ADDENDA – A-03

The information listed below is to form part of the Contract Documents. All associated costs are to be included in Tender Price shown on Tender Form. Acknowledgment of this Addendum, by number, to be shown in space provided on Tender Form.

PROJECT:
**FORT ST. JOHN HOSPITAL
RESIDENTIAL CARE COOLING
UPGRADE**

2.1 M003 – MECHANICAL DETAILS II

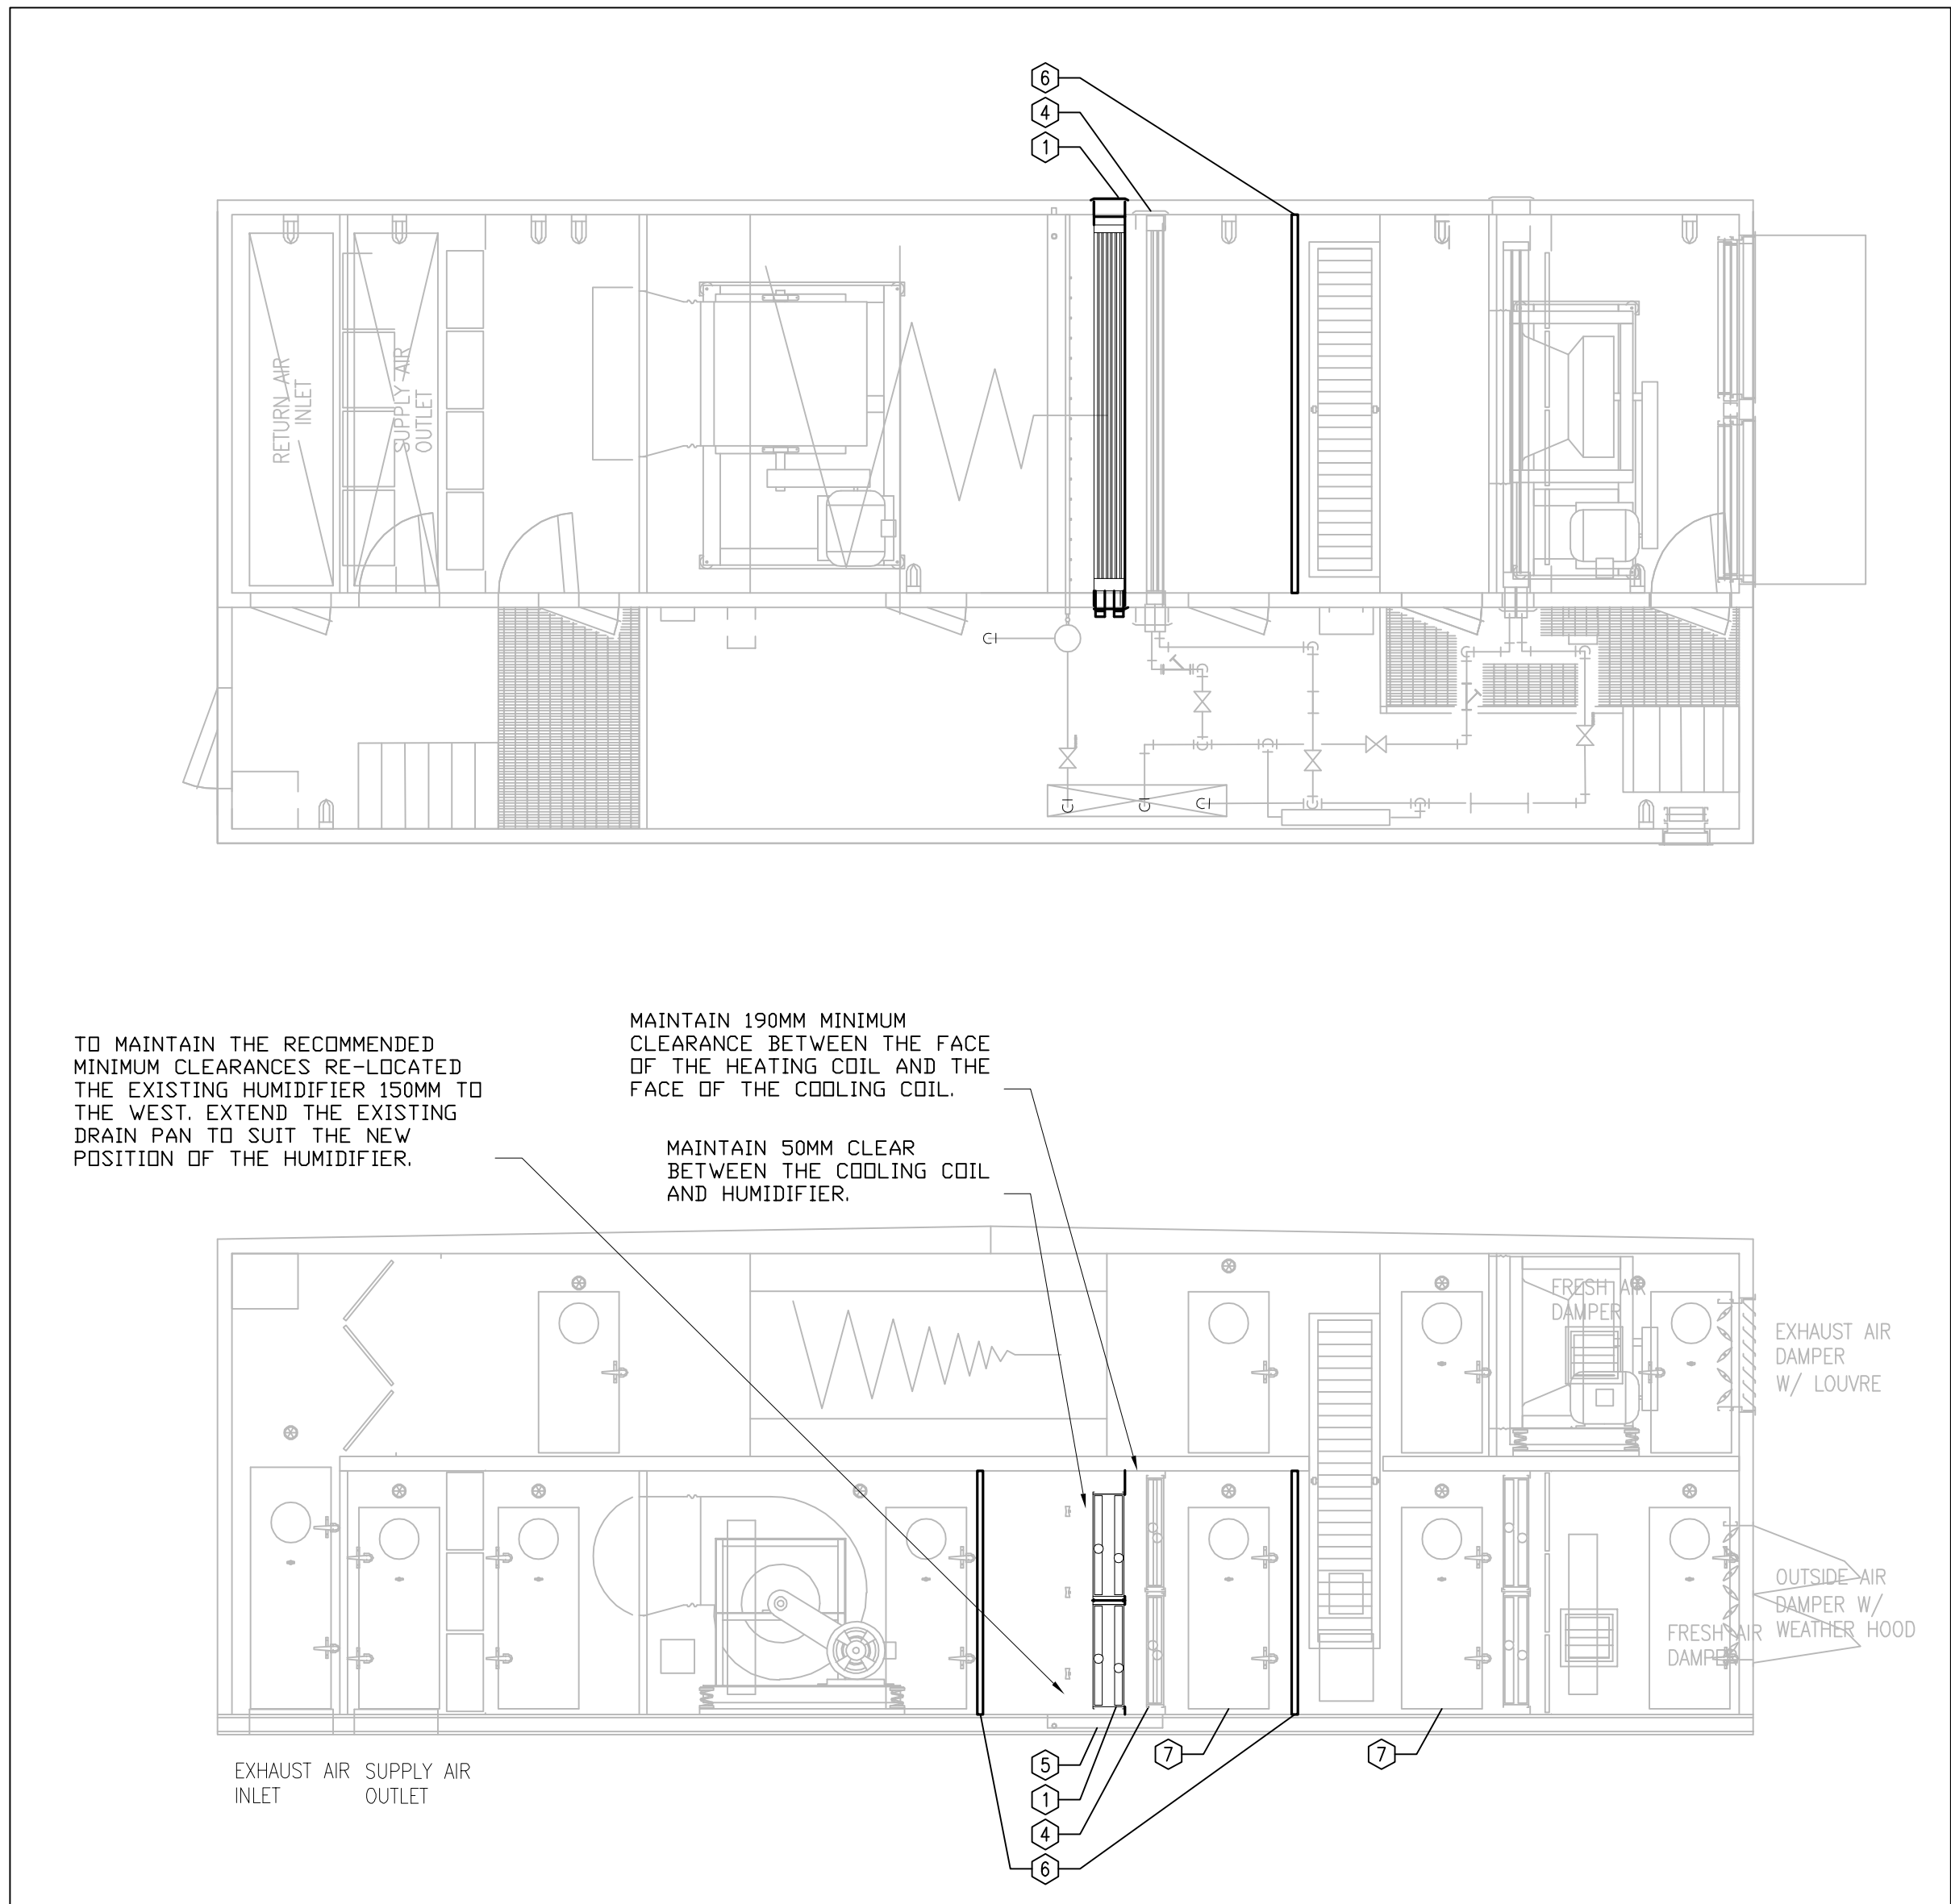
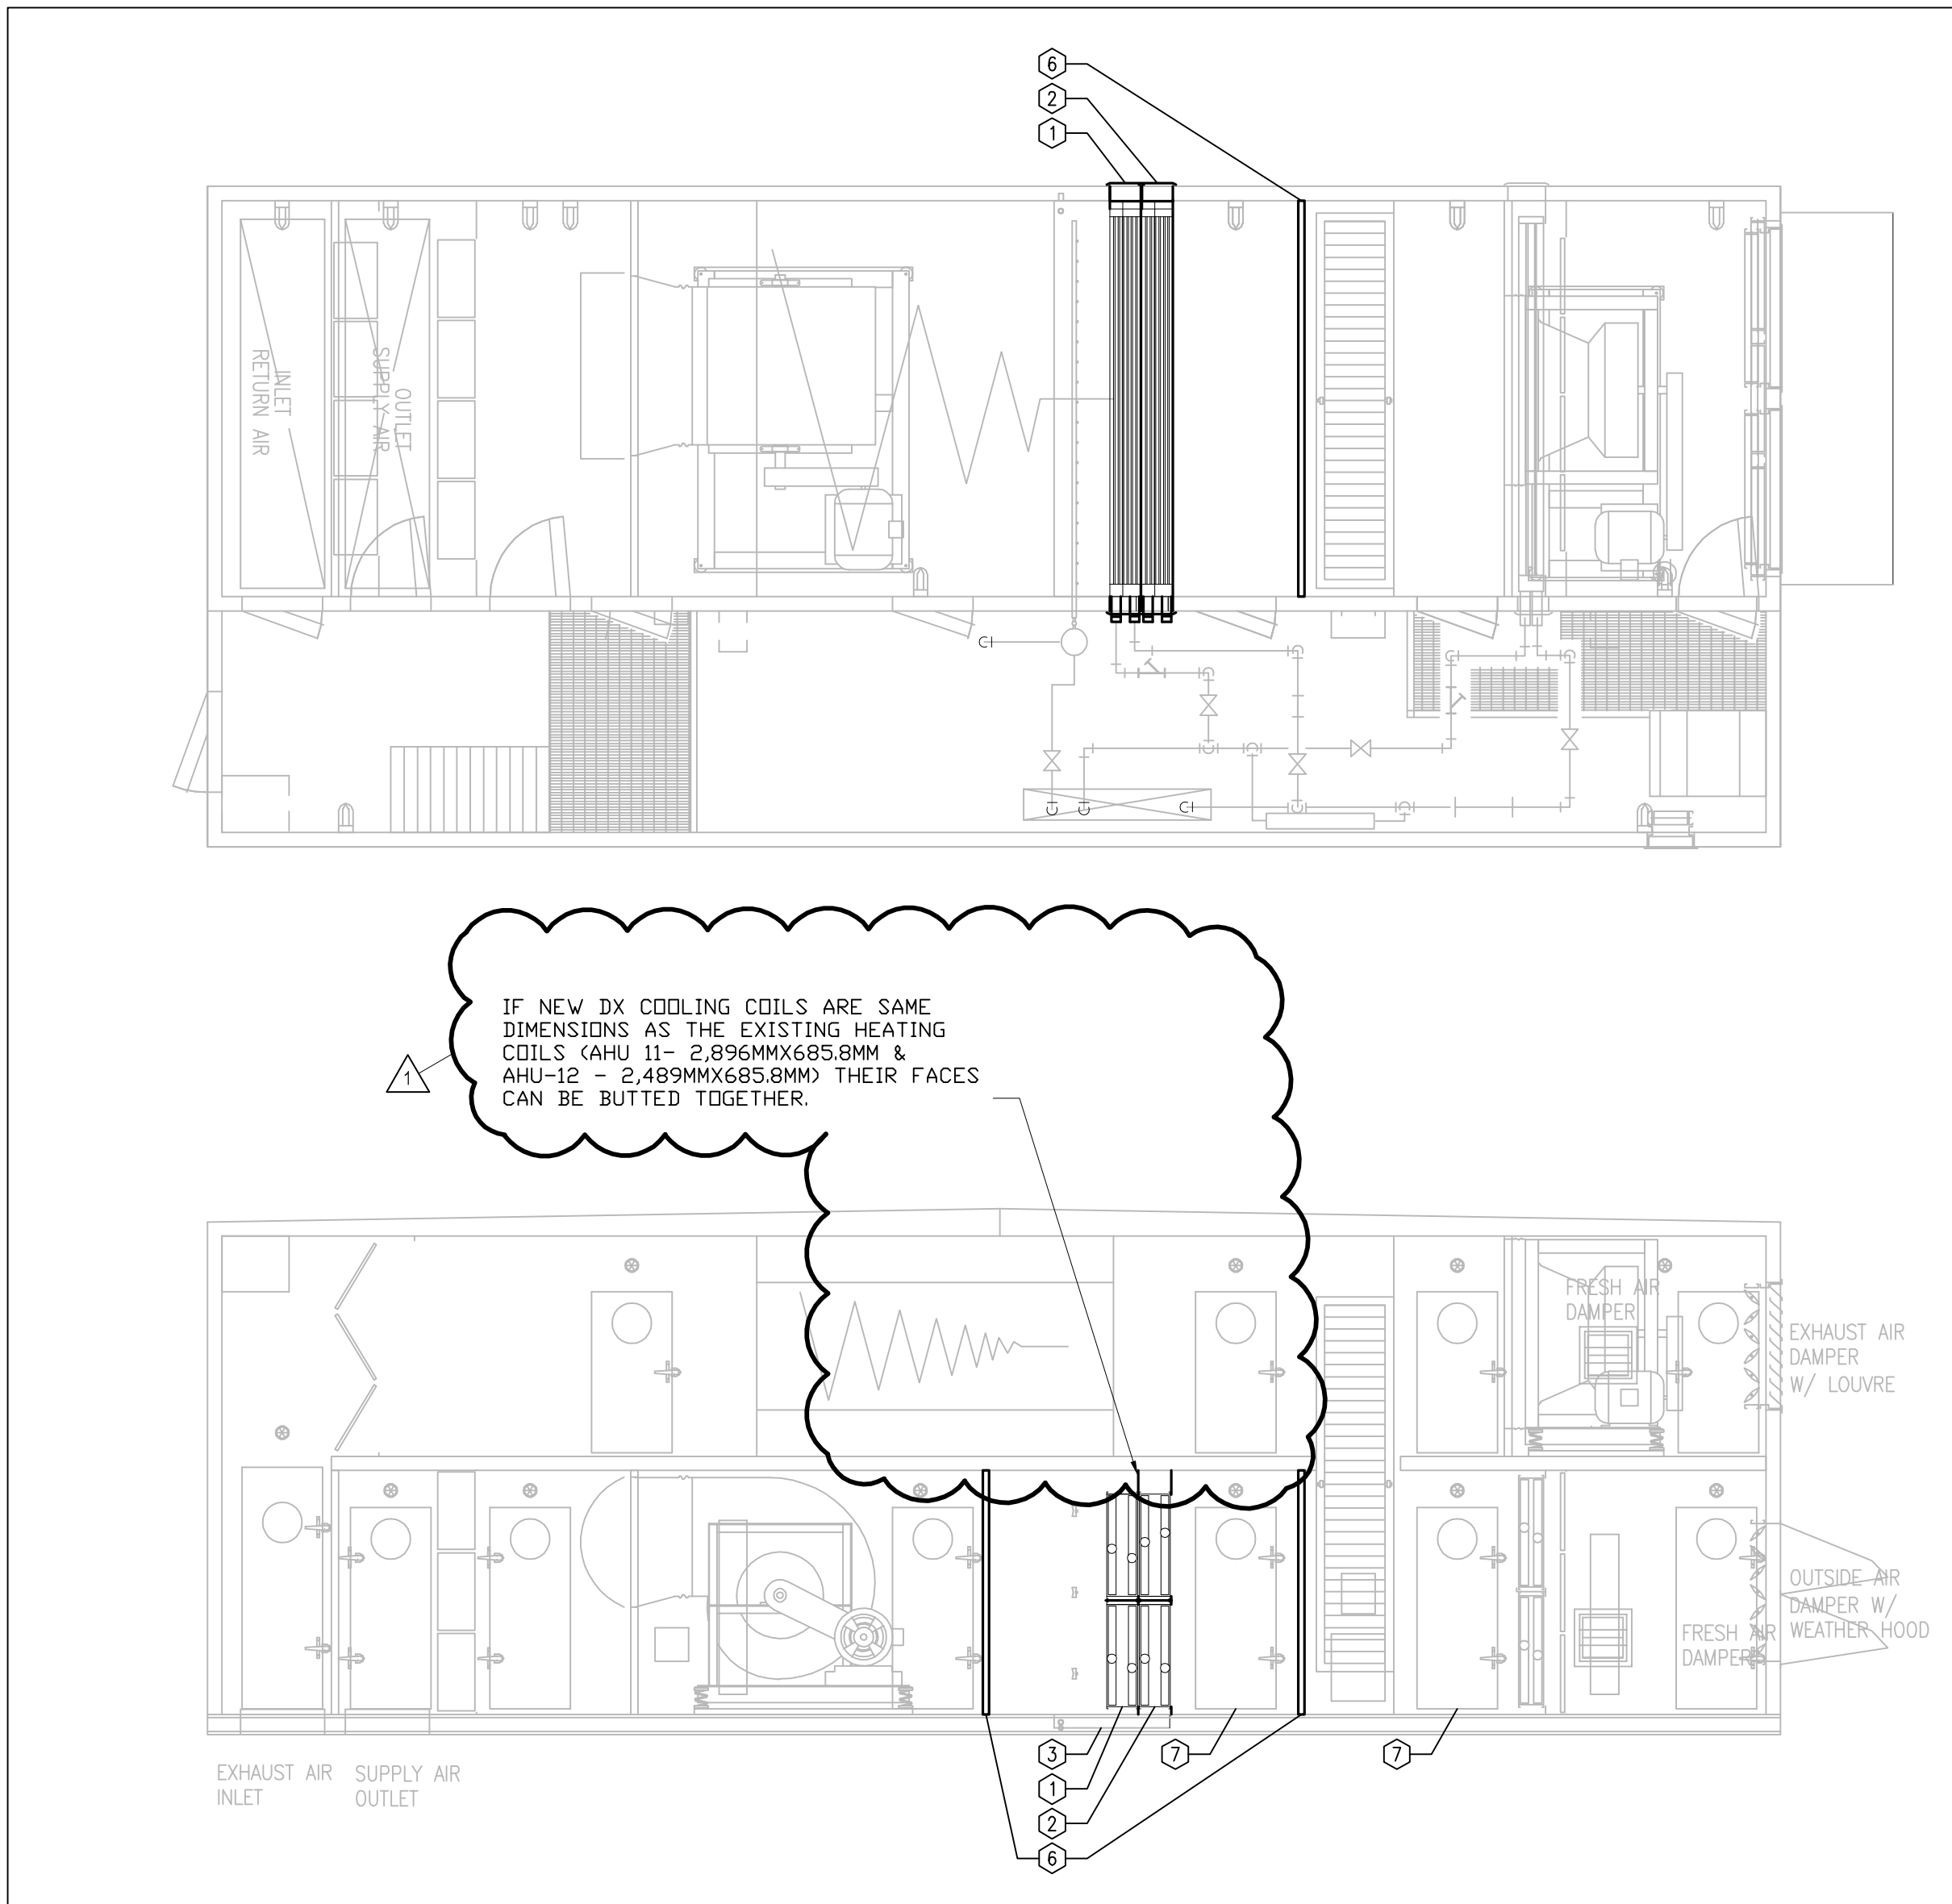
- .1 Revise the details as shown.

2.2 M004 – SCHEMATICS & SCHEDULES

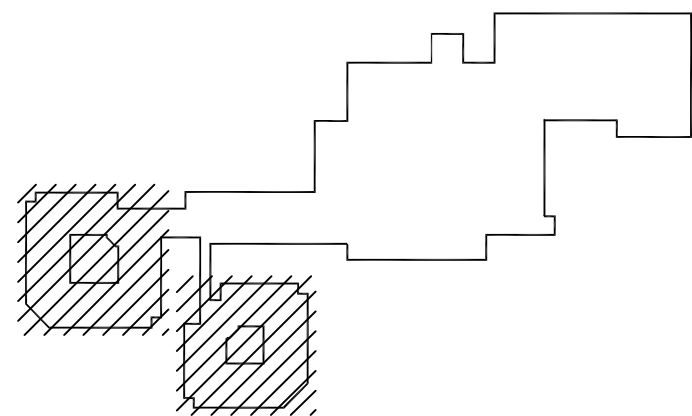
- .1 Revise the Hydronic Heating Coil schedule as shown.
- .2 Revise the DX Cooling Coil as shown.
